# intel® Action Alert

AA-0747-2 (Update)

## Intel® Server Board SE7520BD2 – Heat Sink Fastener Pins Not Fully Inserted

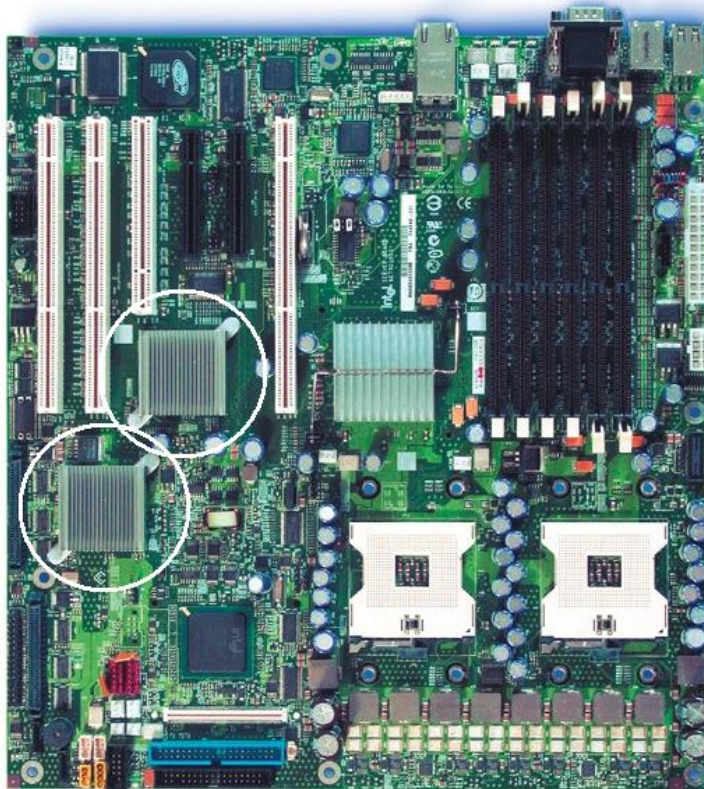
Intel has recently been made aware of an issue with some SE7520BD2 server boards where a heat sink retention pin was found disengaged causing the affected heat sink to move from its required position.

As shown in the following photograph, the Intel Server Board SE7520BD2 has two on-board heat sinks that may be affected by this issue.

Note: SATA only versions, of the SE7520BD2, will only have one affected heat sink. The upper heat sink as pictured above.

Through factory process inspection, Intel has determined that inconsistent pressure was being used to insert the heat sink retention pins from one board to the next. Retention pins that were not fully inserted into the baseboard did not have their tabs fully expanded allowing for potential disengagement during shipping due to excessive shock or vibration.

For affected products stocked in its warehouses the week of January 17, 2005, Intel has inspected, and where necessary reworked, all boards. All new builds starting from January 18<sup>th</sup>, 2005 and going forward will have heat sinks mounted using a new process including an end of line visual inspection. Boards assembled with the new process will have a serial number starting at BZBD504xxxxx.

Intel recommends that customers with in-house inventories that fall within the specified board serial number range visually screen for possible heat sink pin disengagement and manually check that all heat sink pins are fully engaged. Based on the visual screen results, Intel recommends the following:

- 1) If a heat sink is found to be fully removed from the baseboard, Intel recommends that the board be returned using the standard RMA process. These boards have a potential of other component damage due to heat sink contact during shipping.

- 2) If a single heat sink retention pin has disengaged and the heat sink has pivoted from its normal position, Intel recommends that the components around the affected heat sink be visually inspected for damage. If no damage is found, the heat sink can be moved back to its normal position and the loose pin pushed down into place far enough to have its tabs spread open under the baseboard. If component damage is found, the board should be returned using the standard RMA process.

- 3) If a heat sink pin has disengaged but the heat sink is still in its normal position over the chip, Intel recommends that the pin be pushed back down far enough to have its tabs spread open underneath the baseboard.
